CITY OF ALBUQUERQUE

**Re: Unser Crossing
8400 Central Ave. SW
Conceptual Traffic Circulation Layout for DFT Approval
Architect's Stamp 06-14-24 (K10-D045C)**

The conceptual TCL submittal received 06-27-2024 is approved for DHO and/or DFT submittal. When submitting this project through the building permit process, a full Traffic Circulation Layout will need to be submitted and approved prior to building permit. **When submitting a TCL for Building Permit Approval, provide the following:**

TRAFFIC APPROVAL SITE PLAN

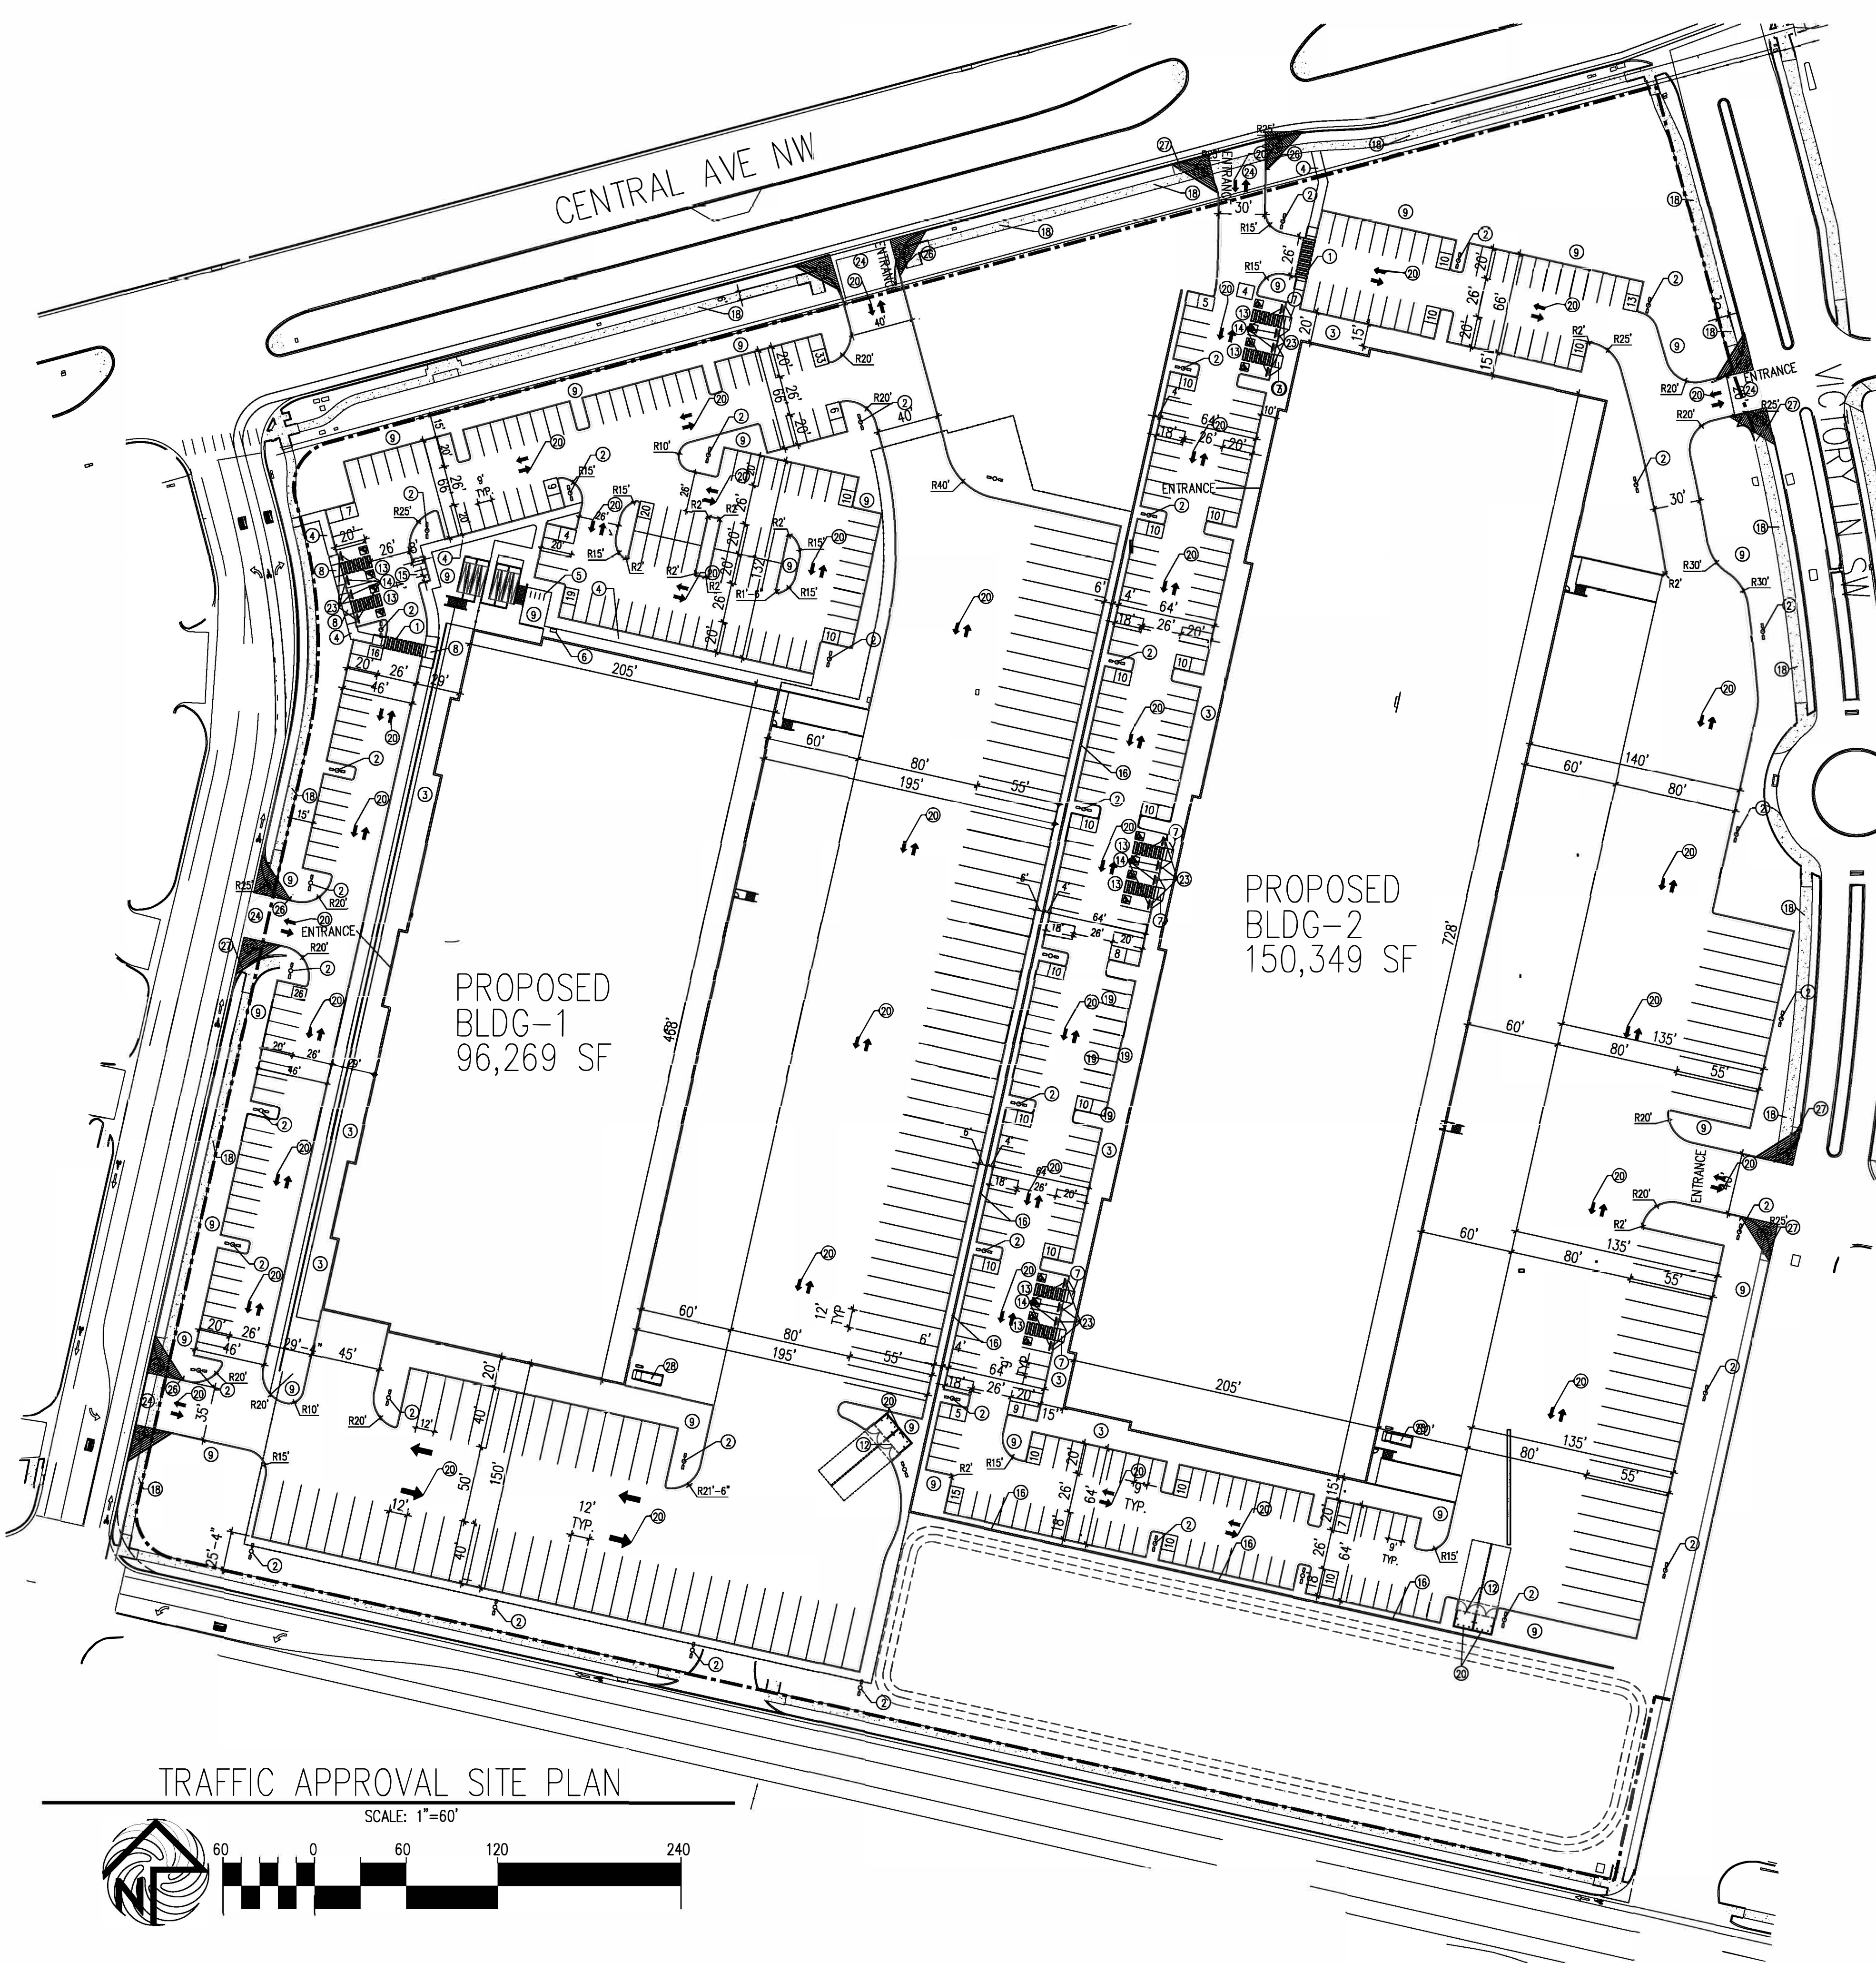
- **An approved plat must be provided.**
- **Identify the right of way name and width on Bridge blvd. and 86th St.**
- **The minimum distance from the intersection of Bridge Blvd and 86th St. to site access off the 86th st. should be 100 ft. Please show this dimension on the site plan.**
- **The minimum distance from the intersection of Central Ave. and Victory Ln to site access off Central should be 150 ft. Please show this distance on the site plan.**
- **Keynote 4: Please provide 6 ft wide ADA pathway from the public sidewalk to the building entrance.**
- **Keynote 26: revocable permit is required for any private signs located within public right of way.**
